+19V
Power
Input

"Standby" power for frontend electronics and SPI Flash

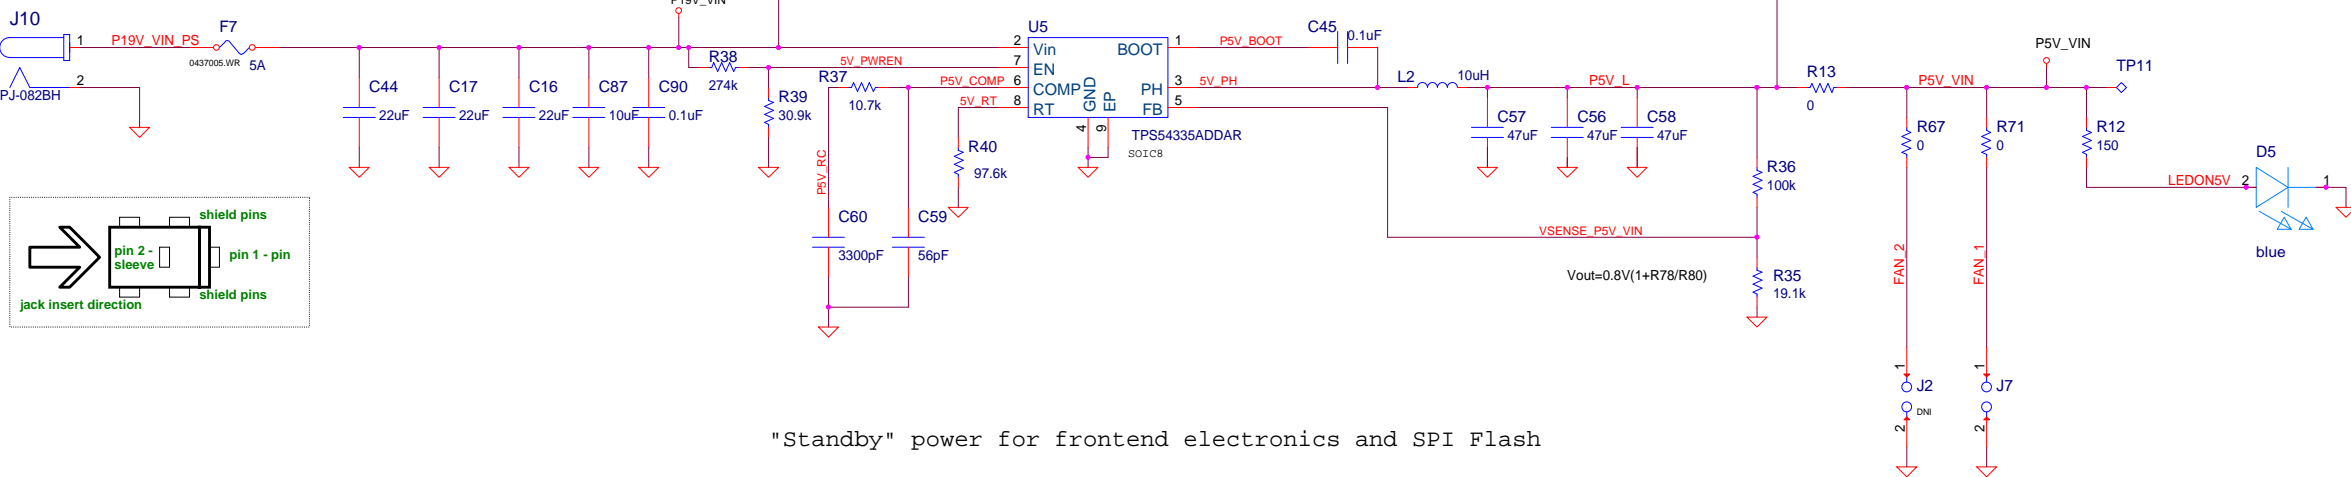
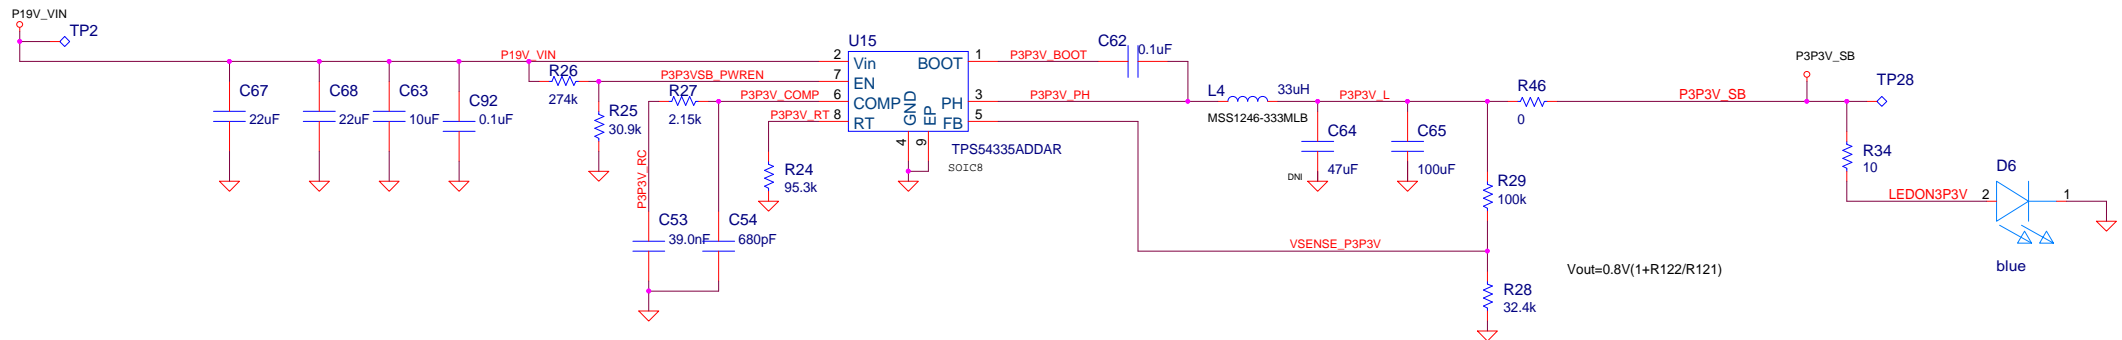
1	2	3	4	5	6	7	8	9
<div>Revisions</div> <div><div>Rev. E.0 : Development version</div><div>Changed Input power to 19V</div><div>Removed 3.3V regulator and added 3.3V_SB regulator</div><div>Changed ITE OVDD voltage to 3.3V</div><div>Rev. E.1: Changed R56 to install and R55 to DNI - The power for the MSP430 will be supplied by the input power not the debugger</div><div>Changed J12 and J14 to DNI</div><div>Changed Title to accommodate new part number</div><div>Rev. A : Removed ESD number, General clean-up, Changed Revision to A</div></div>
